# Application to Amend a Planning Permit S72

| Planning Application No: | PLA0358/18                   |
| Address:                 | 44 Clifford Street, Warragul |

AMENDMENT TO PLANNING  
PERMIT PLA0358/18 CONDITIONS  
& ENDORSED PLAN

**SITE PLAN**

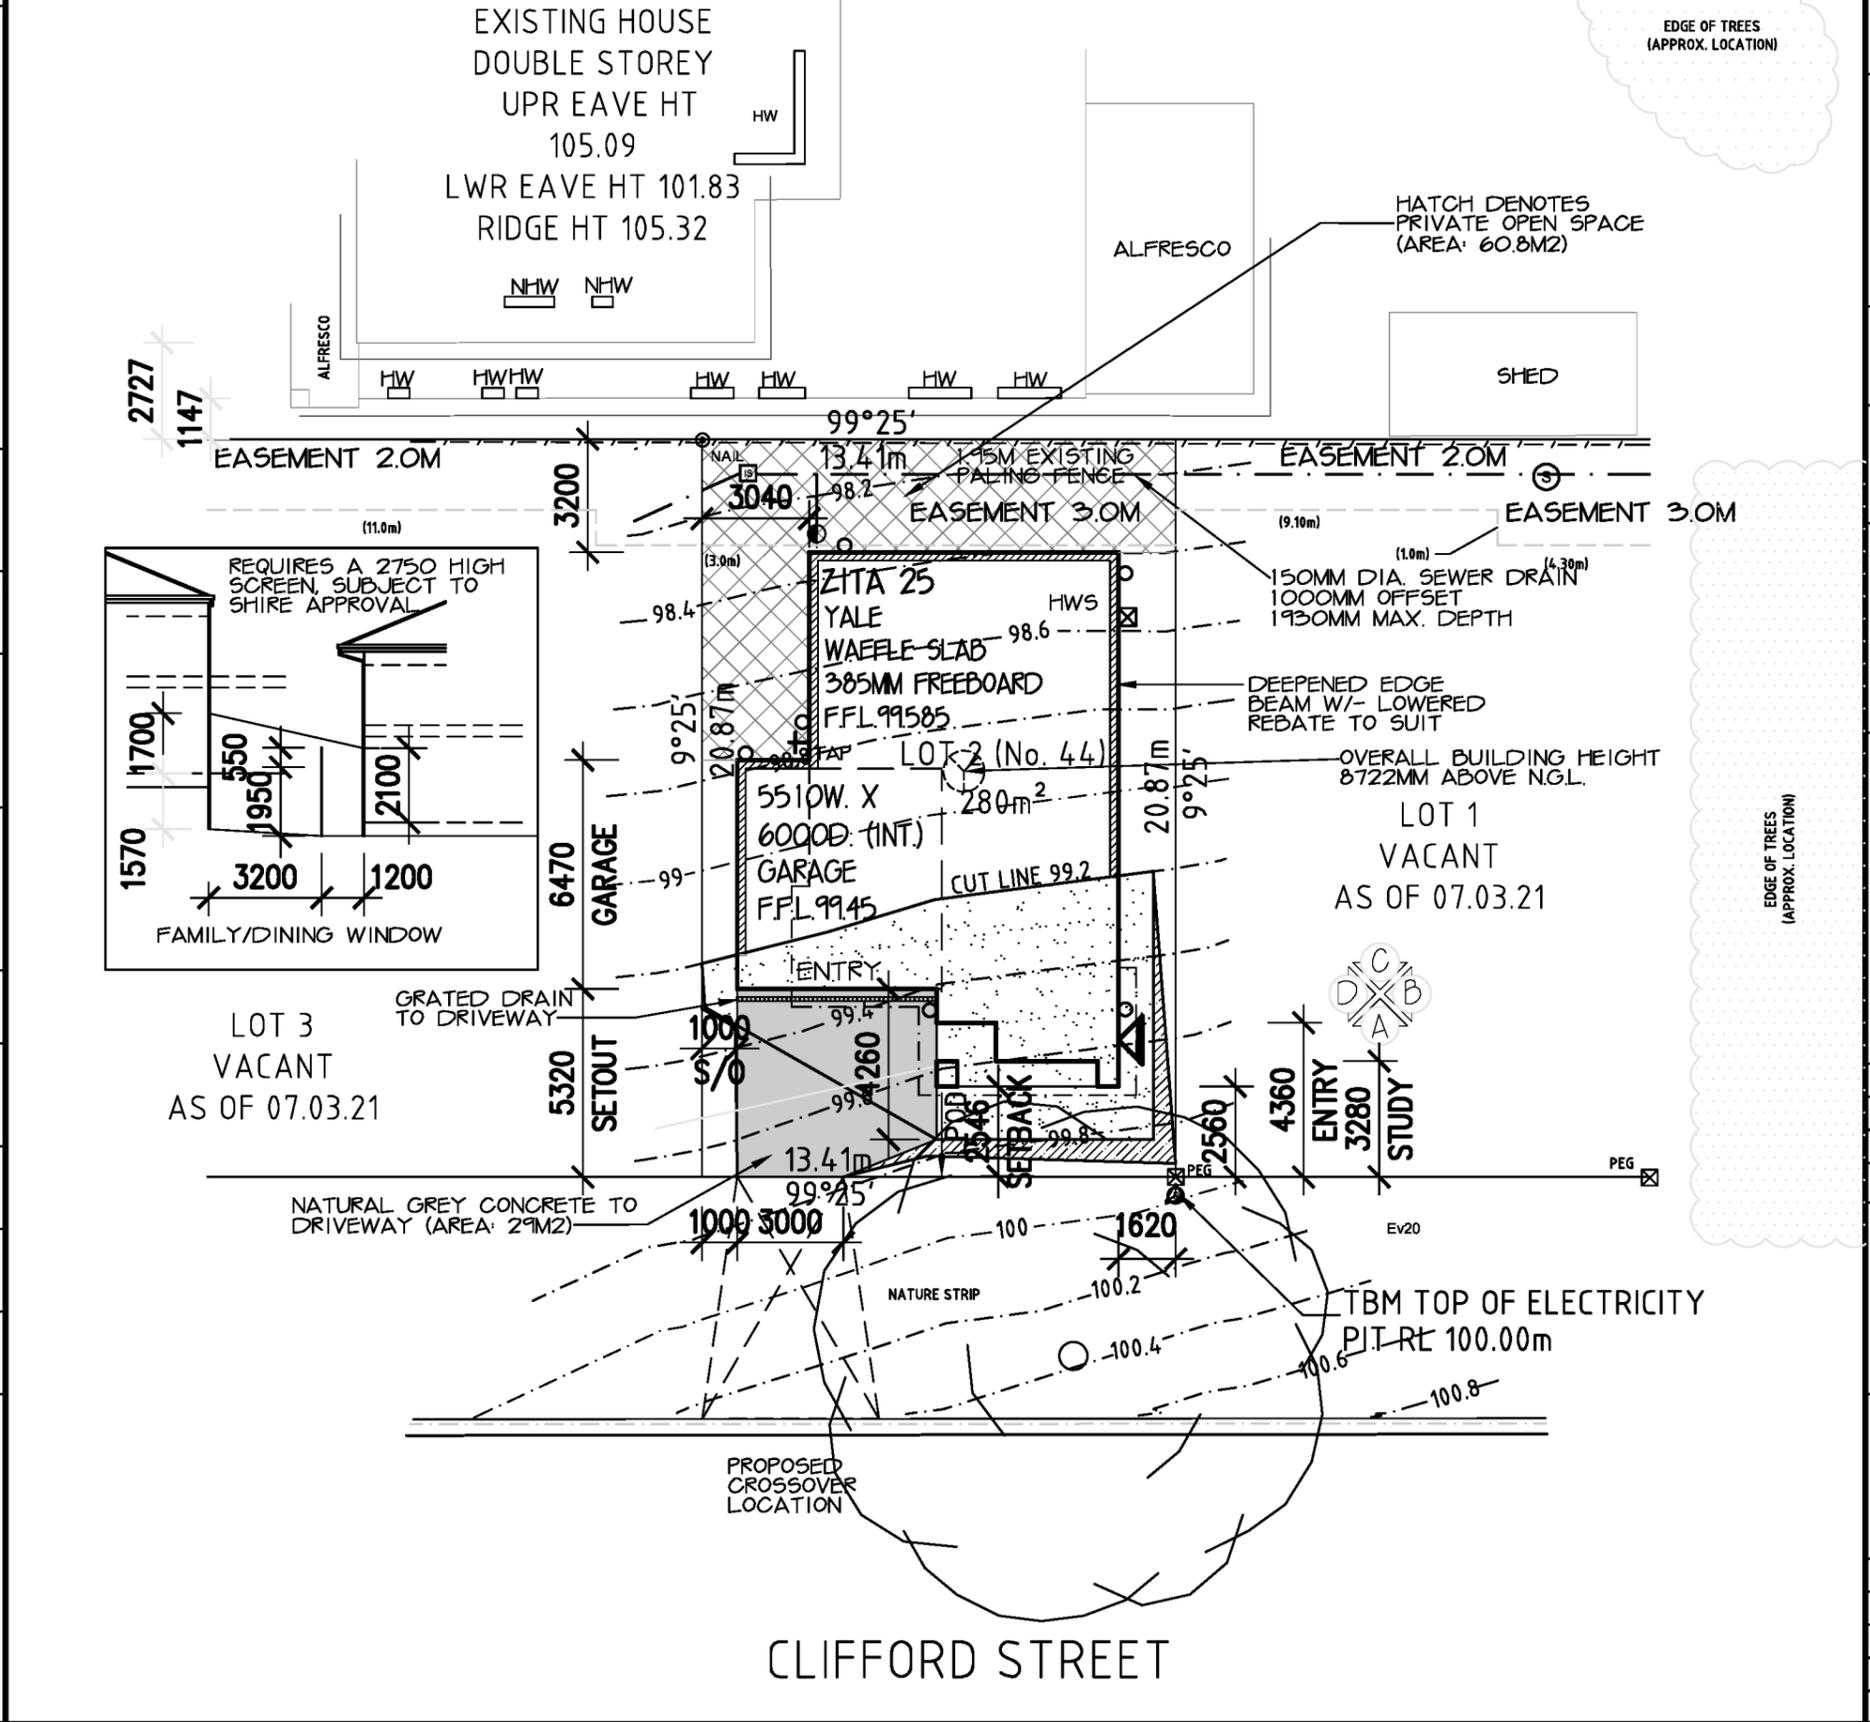
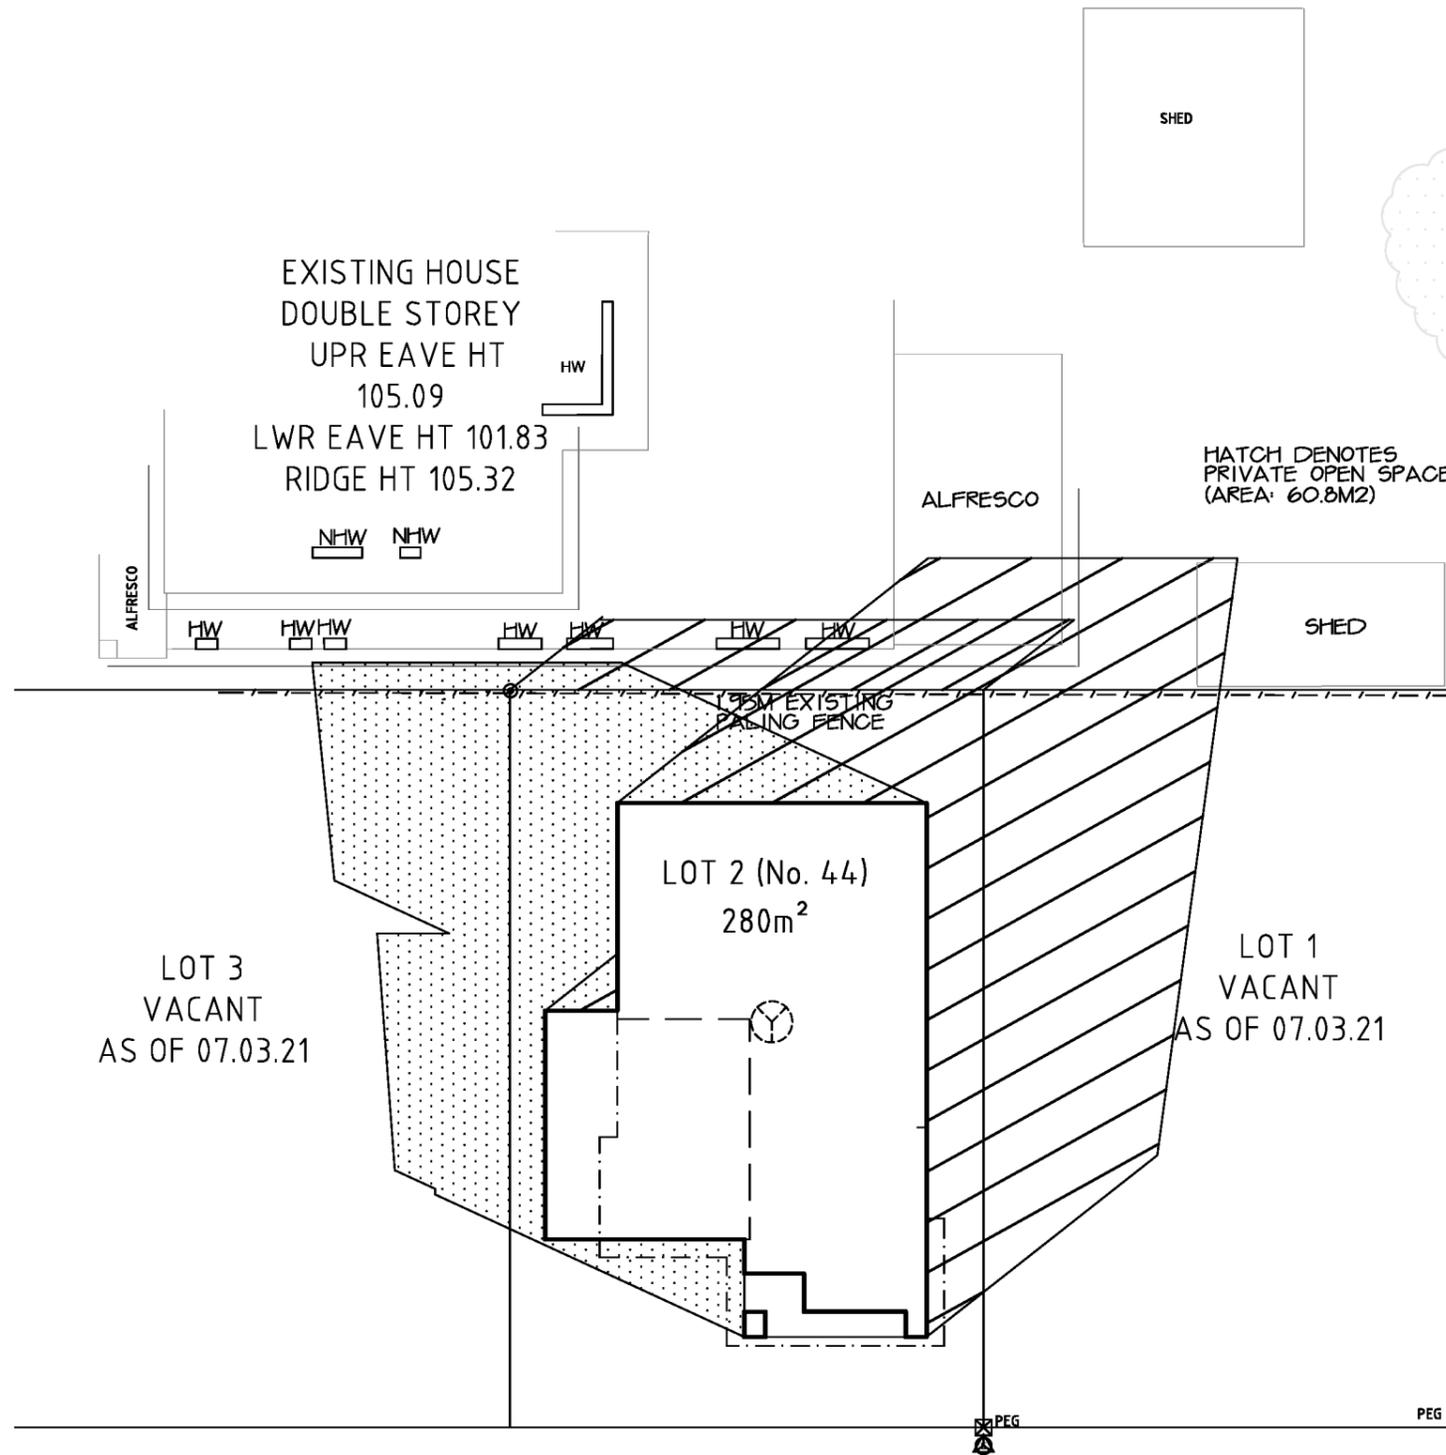
As stated previously, this Application also seeks to substitute the Building Plans approved under PLA0358/18 with Building Plans prepared by Metricon (Job No: 722365).

Both sets of Plans propose Dwellings that are double-storey residences. Notably, the new Metricon Plans changes the siting of the building and the floor plan, which both impact upon road setbacks, overlooking and overshadowing considerations that have been previously approved by Council.

In essence, the Metricon Plans have a slightly closer setback to Clifford Street to facilitate a greater setback from the existing Dwelling at the rear of the property. Additionally, the southern interface of the Dwelling has been modified, which in turn enhances the amenity of neighbouring properties by improving overlooking and overshadowing aspects of the development.
